STAFF'S
REQUEST ANALYSIS
AND
RECOMMENDATION

06PR0385

Blackwood Development Co.
(Blackwood Southshore Shops)

REQUEST: Approval of a buffer landscape plan.

06PR0385

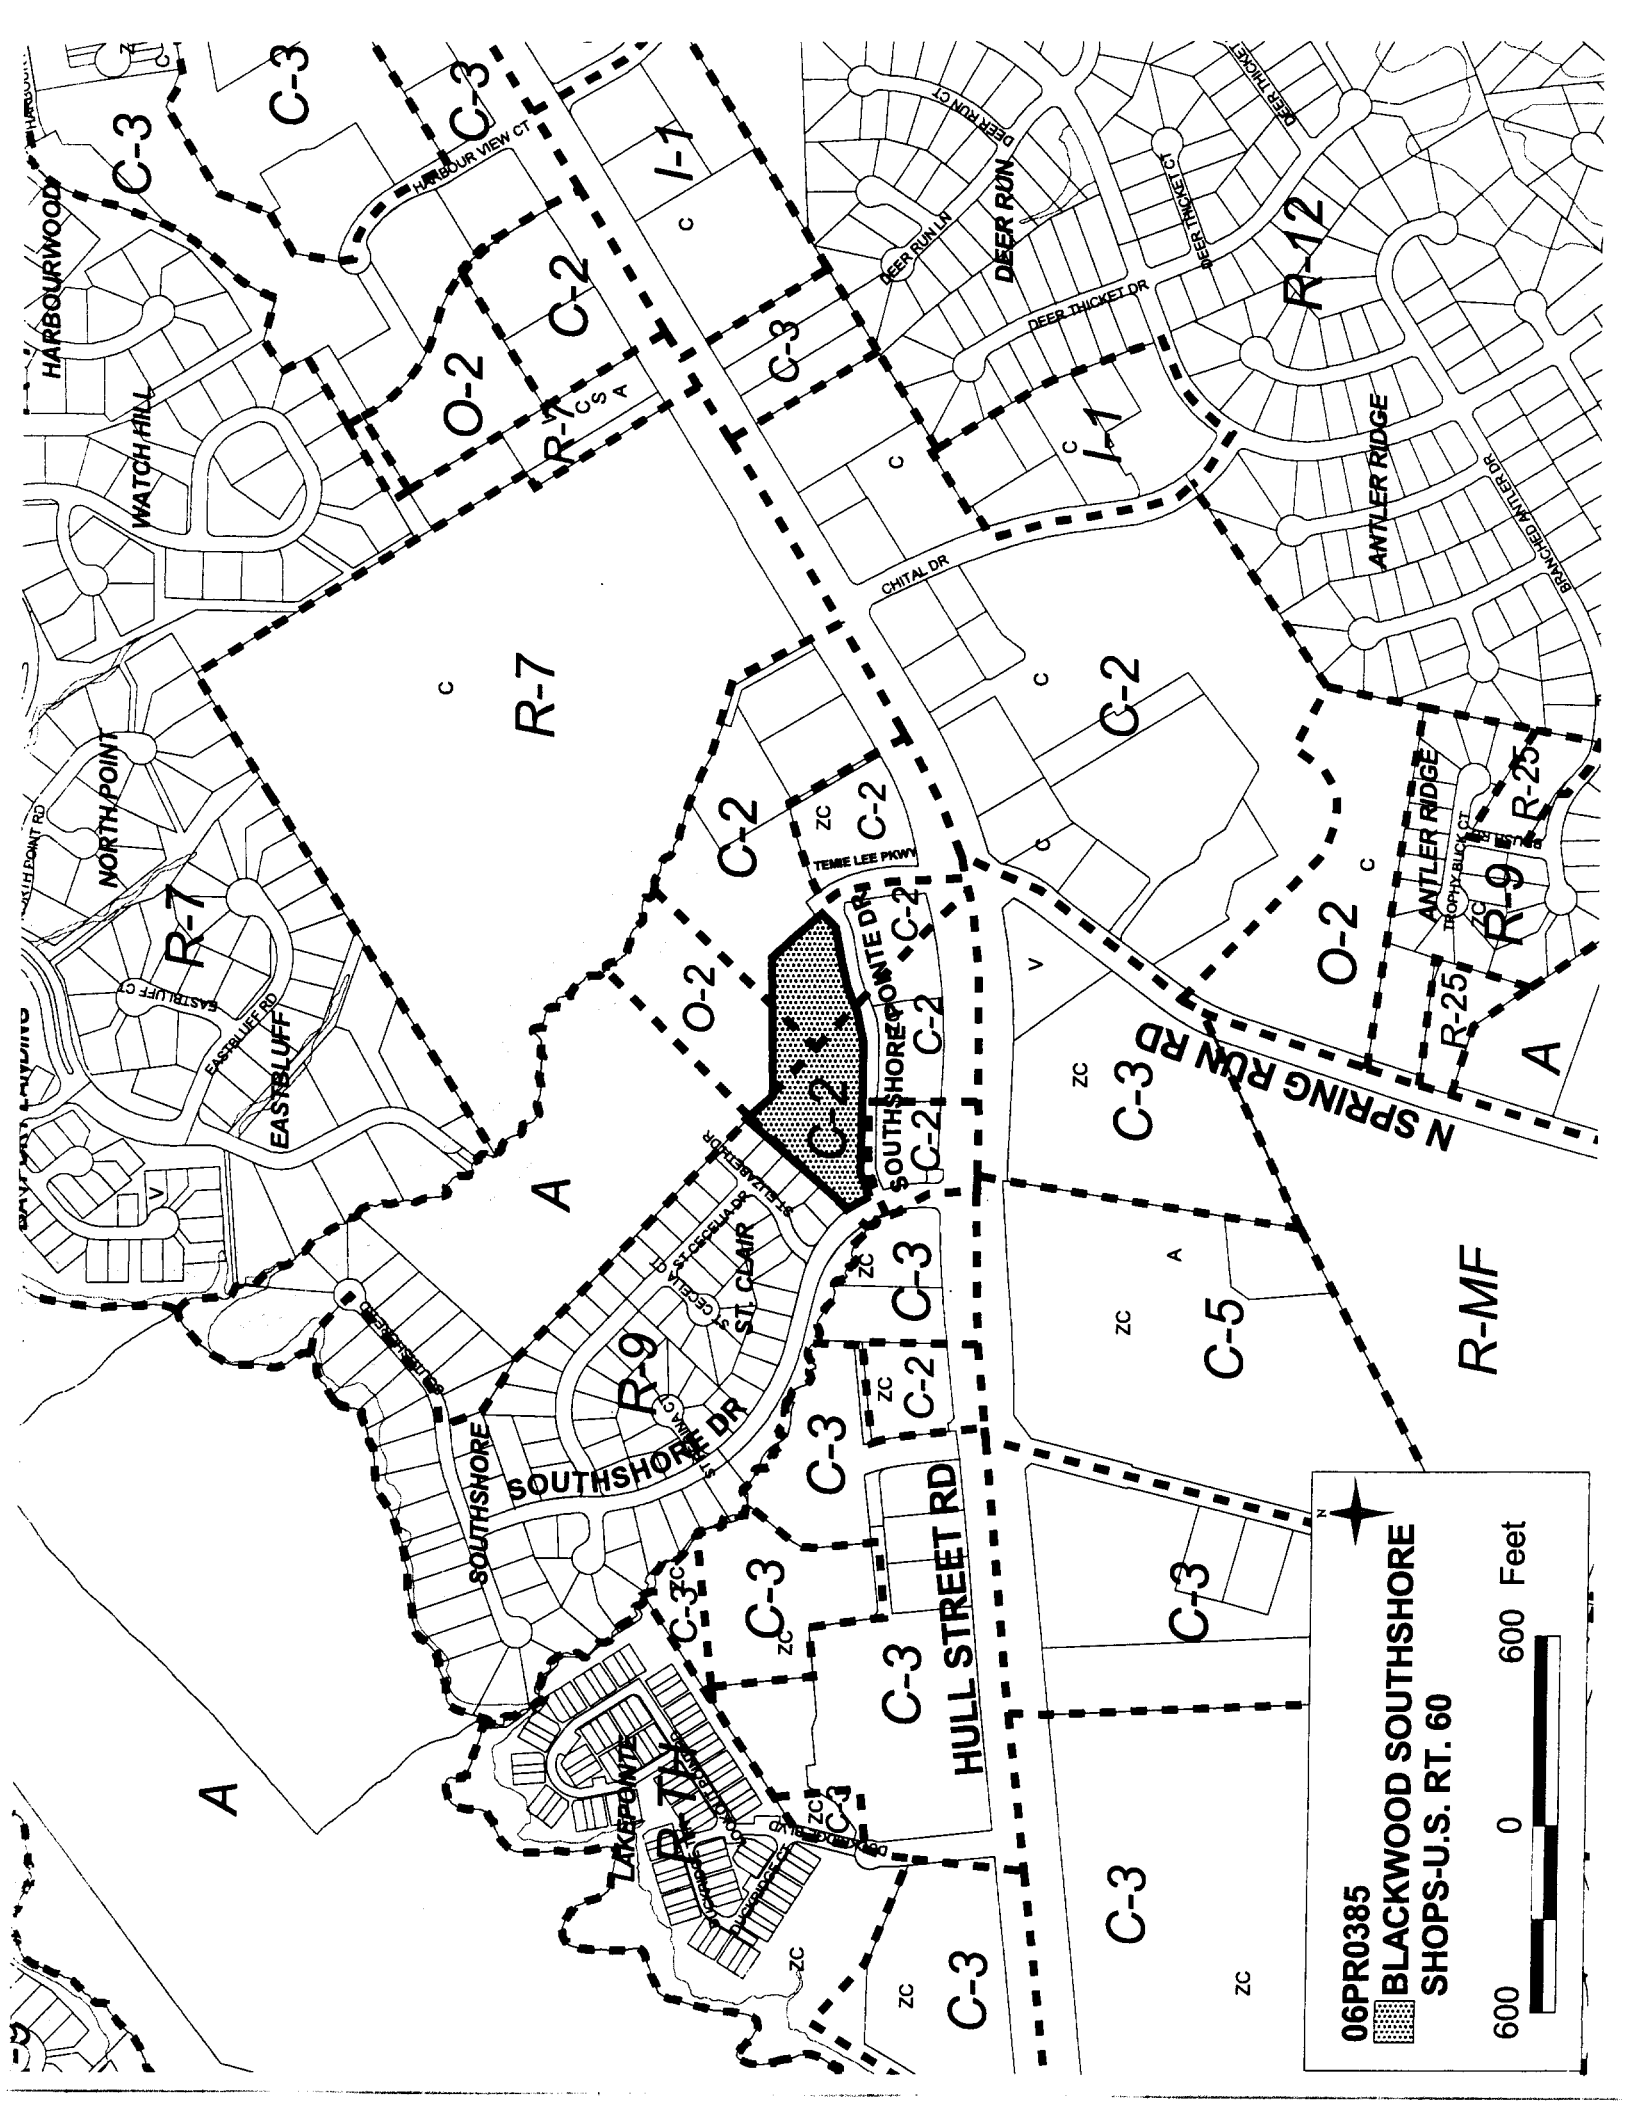
- A. The plantings are primarily evergreen trees and shrubs that will add greater visual density to the deciduous trees within this buffer area.
- B. The rear of the shopping center that backs up to the adjoining homes does not include rear doors or vehicular access. This provides the effect of having a high masonry screening wall that separates the homes from most of the shopping center activity.

In the fifty (50) feet of buffer between the commercial and residential land uses, trees either did not exist or were removed during grading operations. The condition speaks to either situation, which caused the need for the applicant to prepare a landscape plan for the replanting of the open buffer areas.

The applicant has provided an acceptable landscape plan for the replanting of the open buffer areas and has designed the shopping center to minimize commercial activity toward the residential district. Staff recommends approval.
